Lemon Creek Ranch Lift Station RFCSP
Solicitation Number: CO-00490
Job No.: 21-3000

ADDENDUM 2
December 6, 2021

1
TRANSVERSE RESERVOIR SECTION
 SCALE: 3/8" = 1'

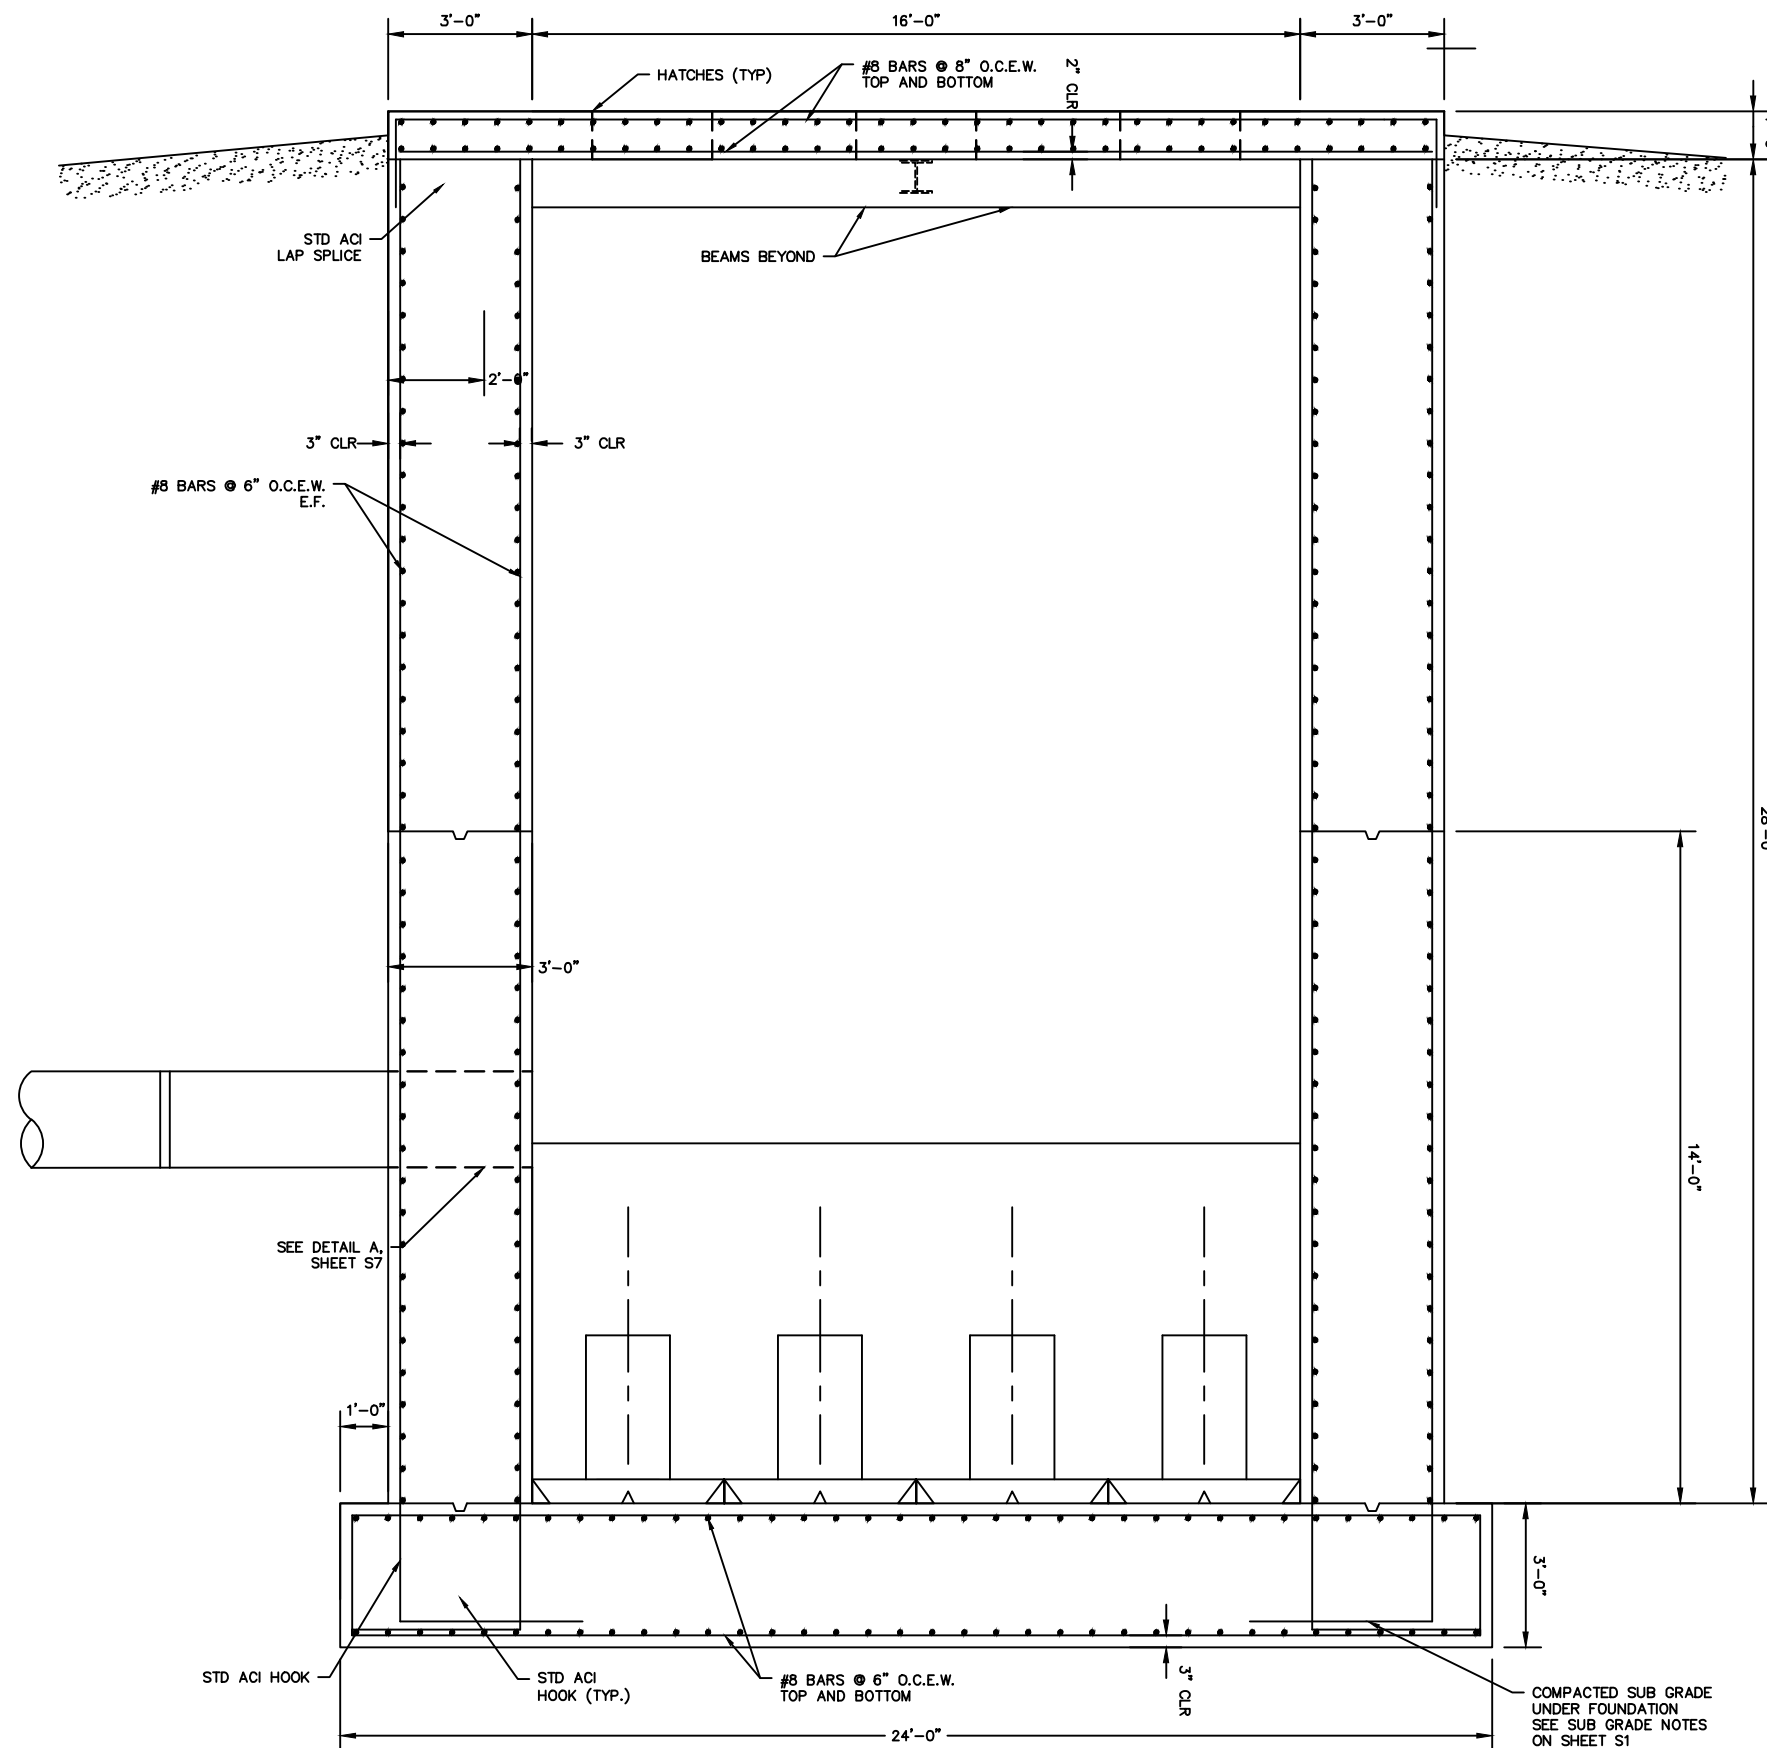
SC 2.0 The Wet Well has been revised to be 29-feet deep from what was previously shown (19-foot deep wet well). There will be a new 36-inch thick concrete wet well and 36-inch wet well foundation (unsealed sheets) re-issued to be part of the base bid. Contractor shall submit a price with the lift station line item 1 that includes the cost of the updated S1/A, S2, S3, S4, S5, S6/A, S7/A sheets.

DATE: AUGUST 2021	SAWS PROJECT NO. 21-3000	SHEET NO. S2A
DESIGN: JEL	KHA PROJECT NO. 068716102	
DRAWN: ELR		
CHECKED: AF

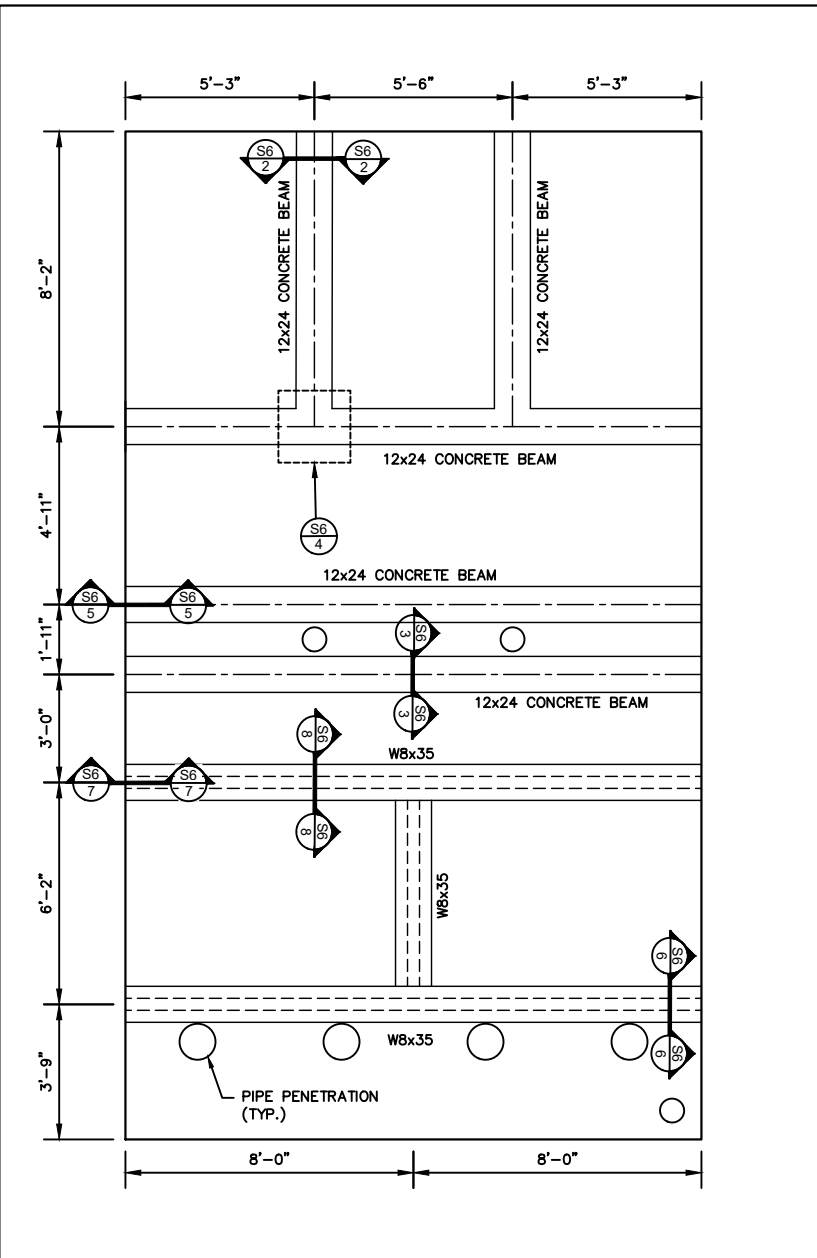
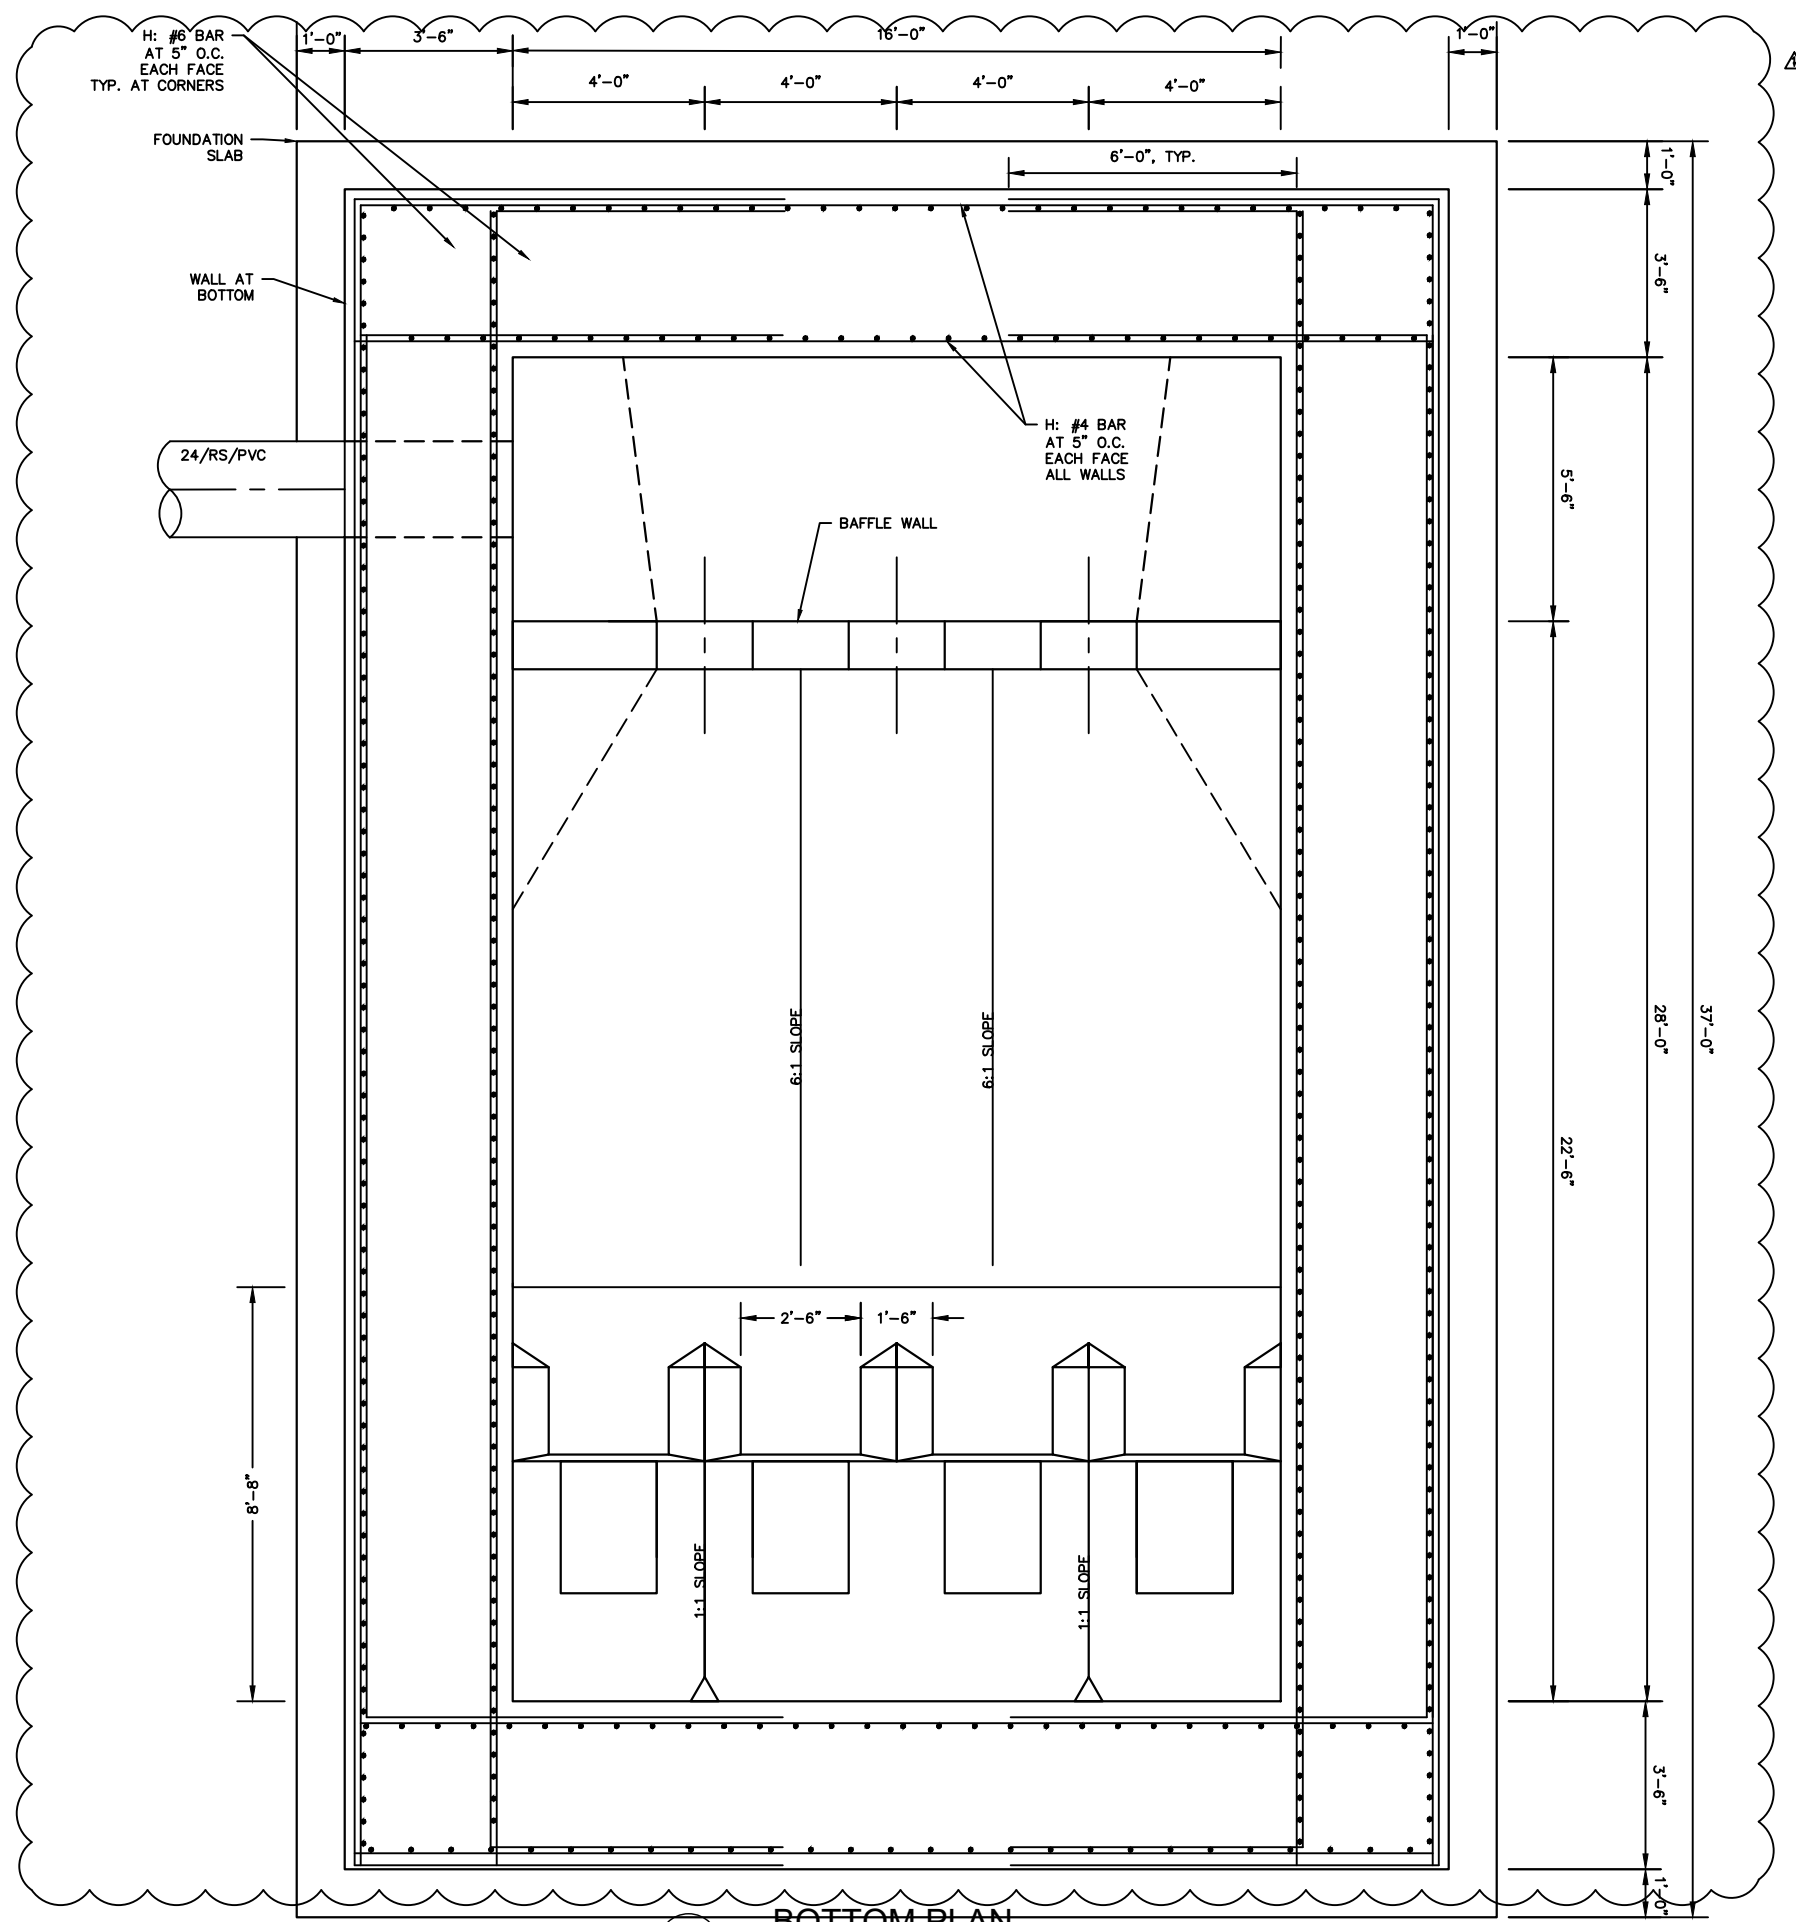
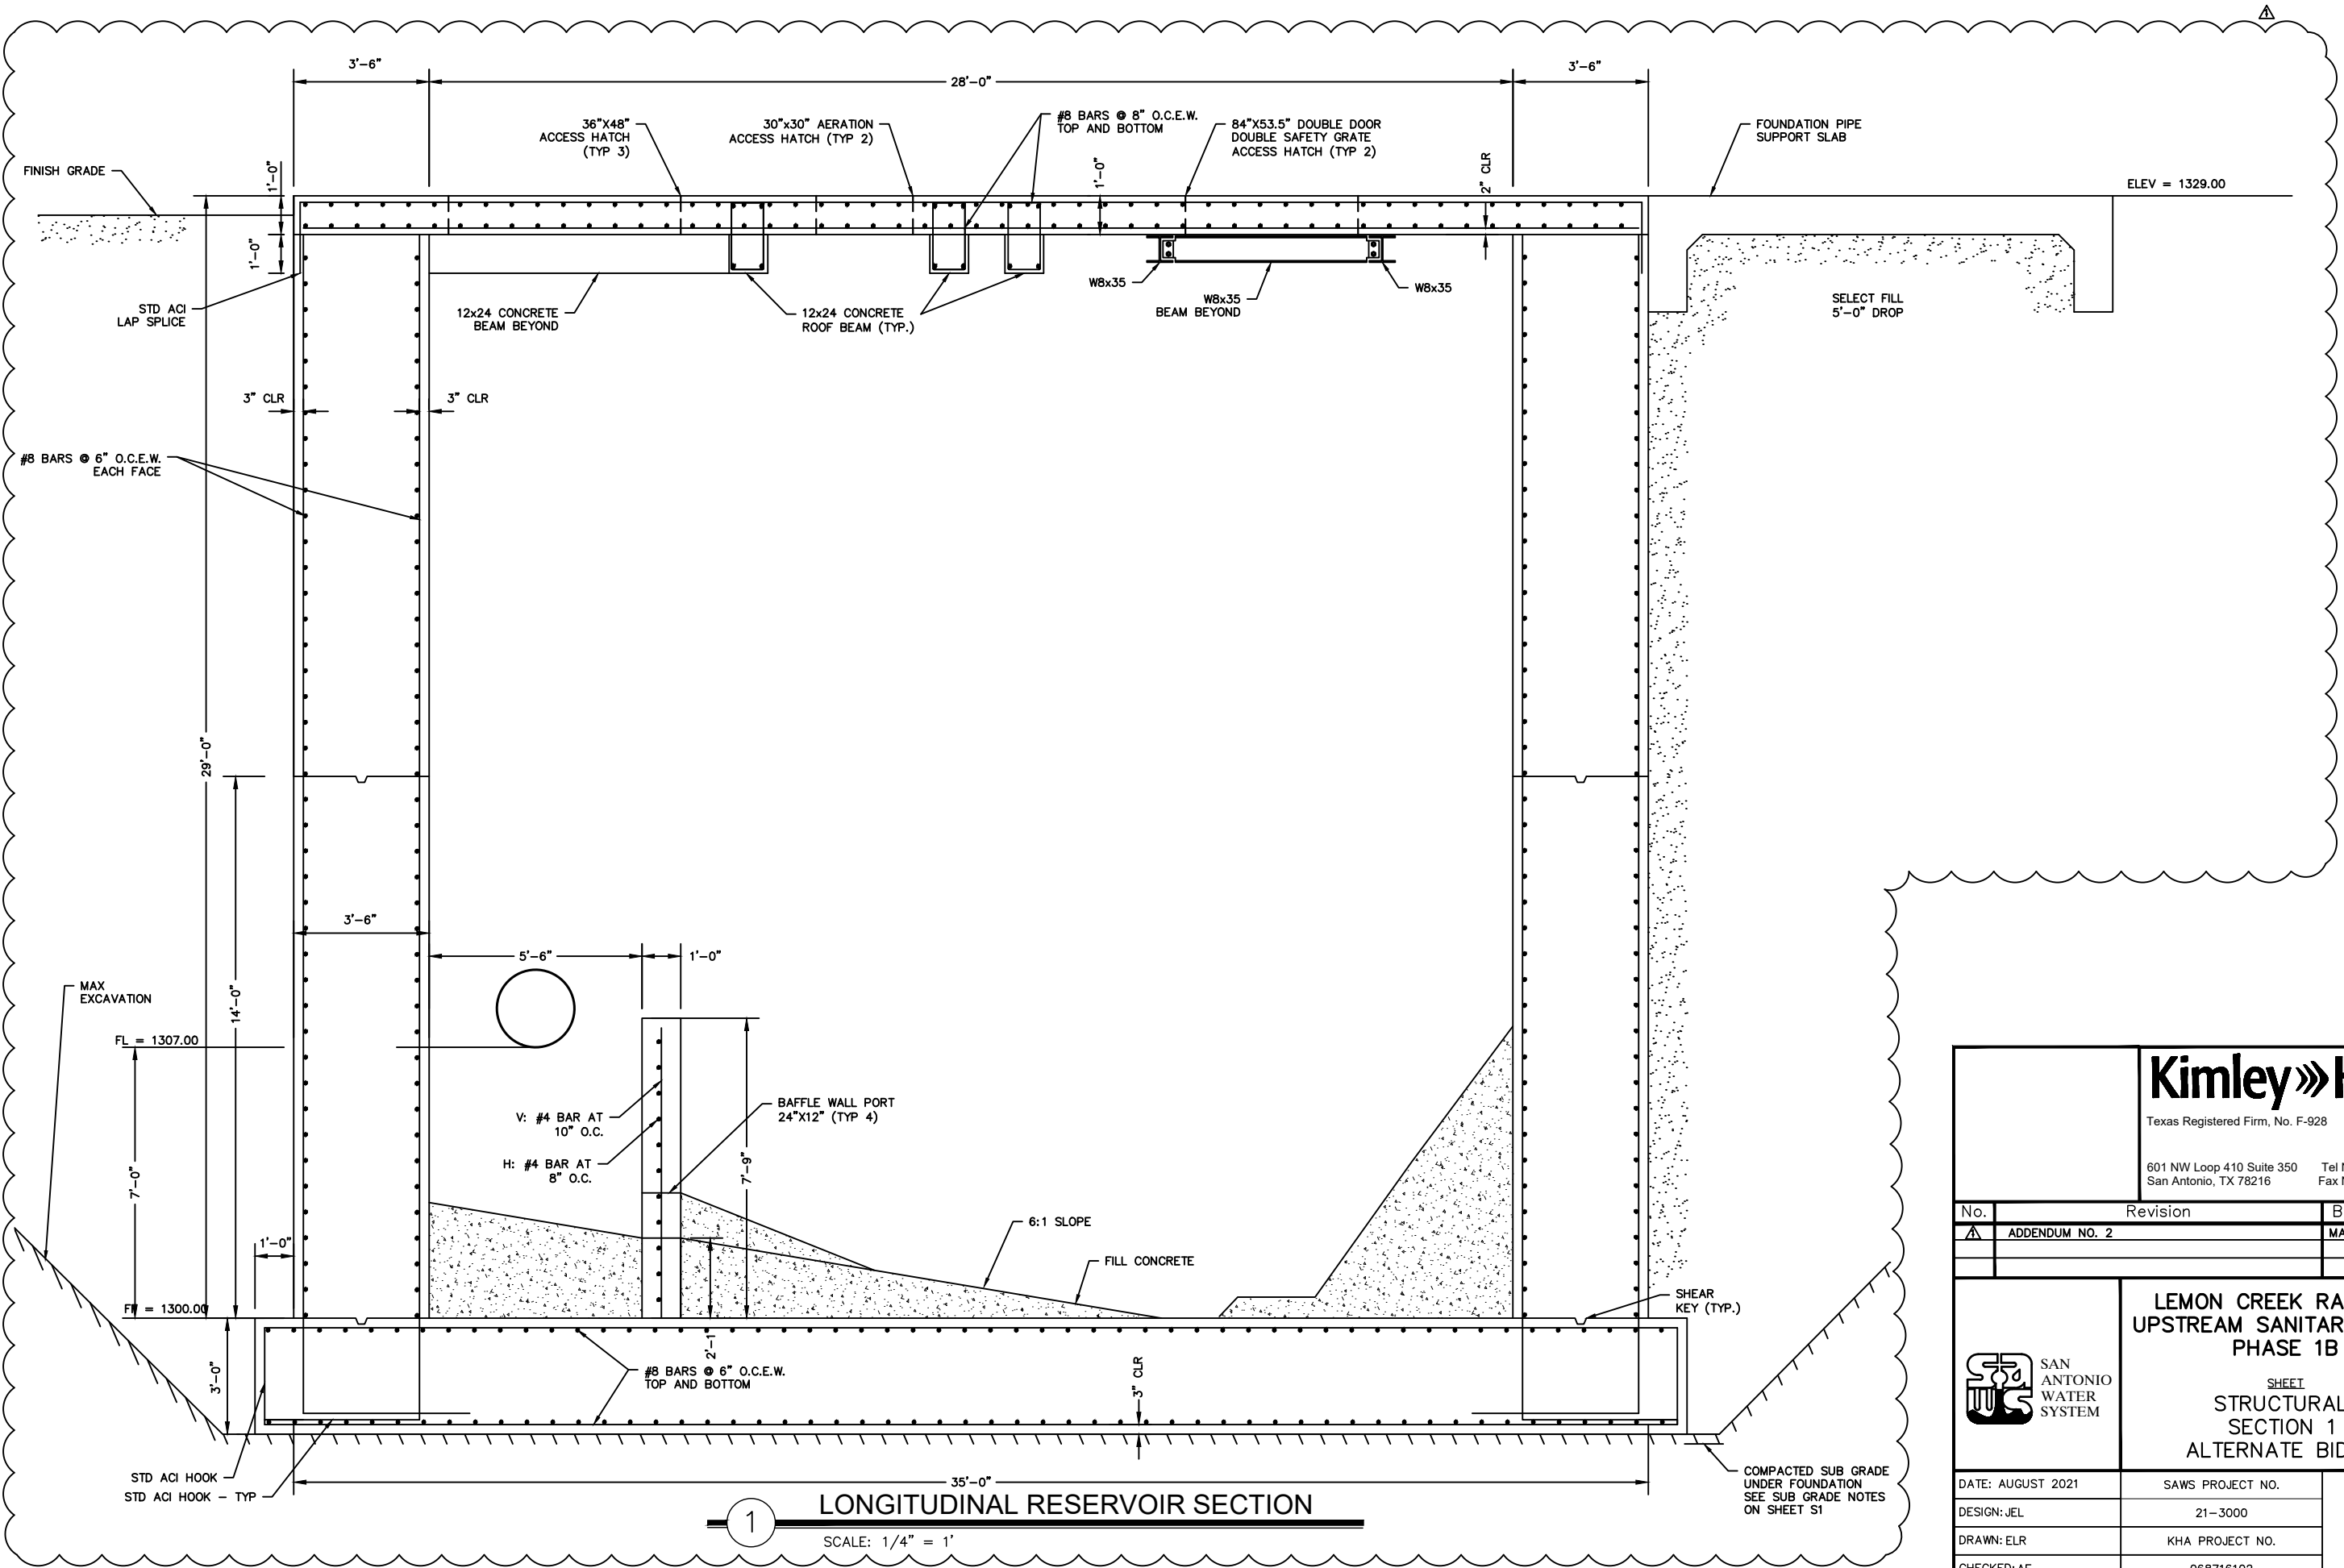
The unit cost for Alternate Bid Item 1A should include all lift station costs with construction of the lift station wet well with thicker concrete walls (42-inch thick) than the base bid as shown in Plan sheets S1-A, S2A, S3A, S5A, S6-A, and S7-A.
